**Validation report form for renewal of crediting period for
CDM project activities
(Version 03.0)**

Title and UNFCCC reference number of the project activity	SHPs Albano Machado and Rio dos Índios CDM Project (JUN1115) UNFCCC #: 6465
Number and duration of the next crediting period	2 nd crediting period 02/07/2019 – 01/07/2026
Version number of the validation report	2
Completion date of the validation report	20/11/2020
Version number of PDD to which this report applies	2.1
Project participants	Rio do Lobo Energia Ltda; Casa de Pedra Energia S.A; and Carbotrader Assessoria e Consultoria em Energia EIRELI
Host Party	Brazil
Applied methodologies and standardized baselines	AMS-I.D – Grid connected renewable electricity generation - Version 18.0
Mandatory sectoral scopes	1 : Energy industries (renewable - / non-renewable sources)
Conditional sectoral scopes, if applicable	N/A
Estimated amount of annual average GHG emission reductions or GHG removals by sinks in the next crediting period	12,474 tCO ₂ e

Name and UNFCCC reference number of the DOE	Earthood Services Private Limited UNFCCC Ref. Number: E-0066
Name, position and signature of the approver of the validation report	 Dr. Kavir

Figure 4: Plot of SHP Albano Machado (PCH Albano Machado in Portuguese)

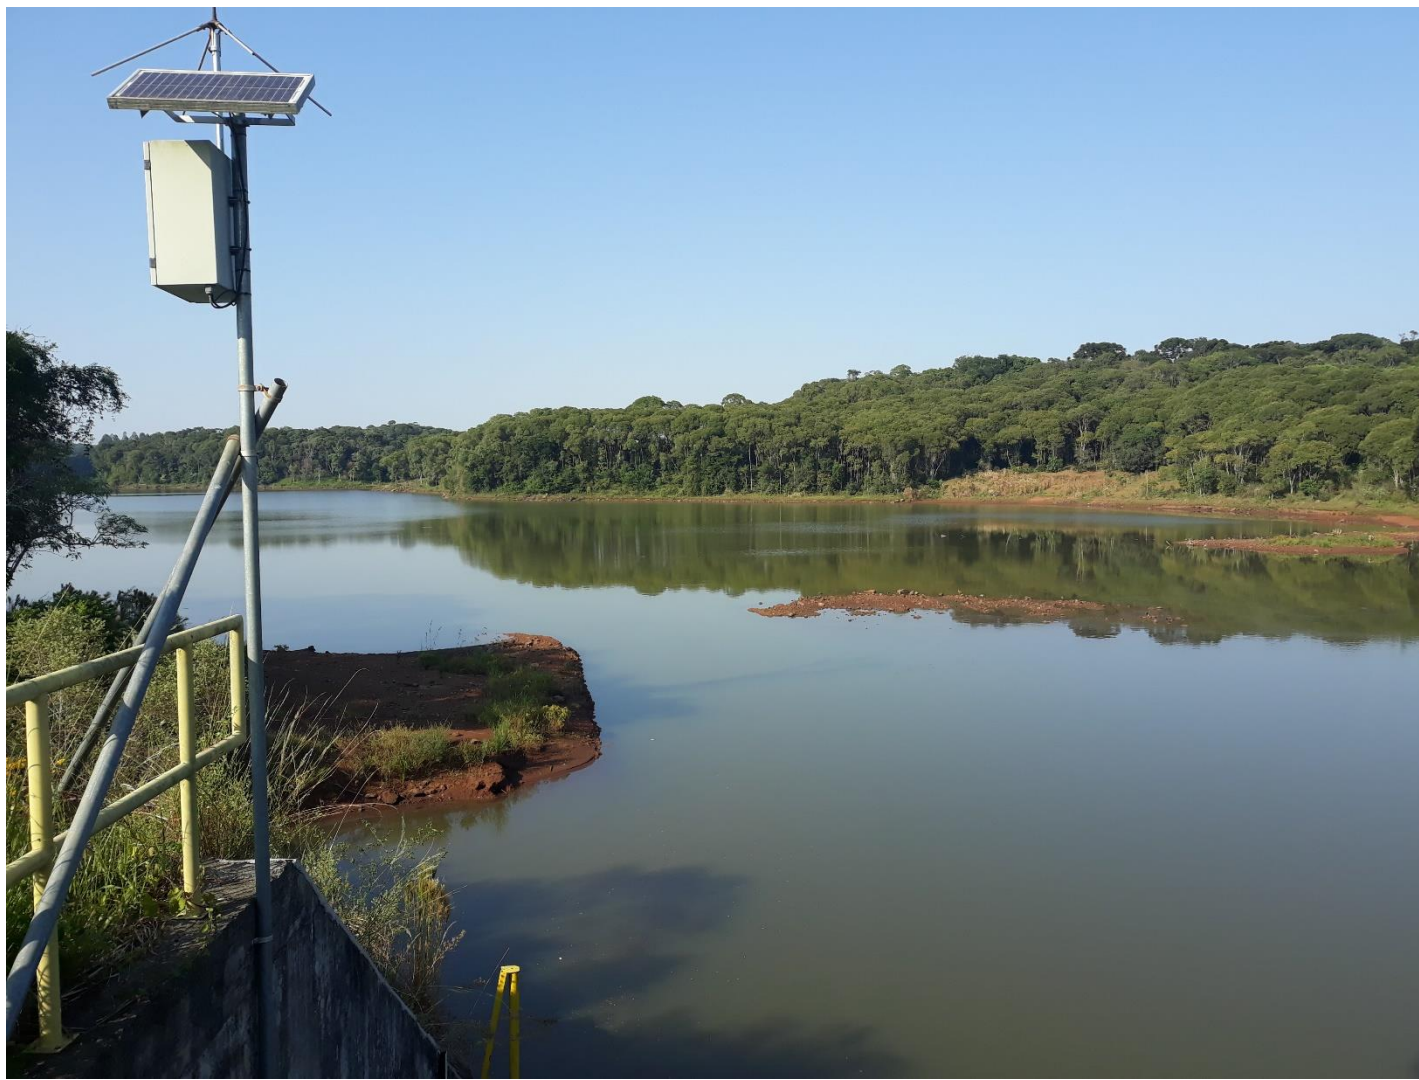
CL ID	01	Section no.	A	Date : 20/11/2020
Description of CL				
<i>It is observed that using the reported GPS coordinates, it is not possible to visibly identify the existence of the plants on satellite map such as google maps.</i>				
Project participant response				Date : 20/11/2020
<i>The geographical coordinates of SHP Rio dos Indios presented a typographical error which was identified in the official document (installation licence) used during the validation process. Amended document was provided to the validation team ensuring the correct information and the PDD was revised accordingly</i>				
Documentation provided by project participant				
Revised PDD version 2.1 Installation License - LI # 375/2008-DL				
DOE assessment				Date : 20/11/2020
The revised PDD and installation license ^{/28/} were provided to the validation team ensuring the correct location of the SHP Rio dos Indios. Moreover, picture of the SHPs were provided in order to evidence the operational status of SHP (see appendix 5)

¹ This information of Longitude from SHP Rio dos Índios was amended from registered PDD where it was described as 50°47'38" W (it was a typographical error). The information presented now correctly reflects the project location as it can be checked in evidence /28/ and Appendix 5. See CL 01 below.
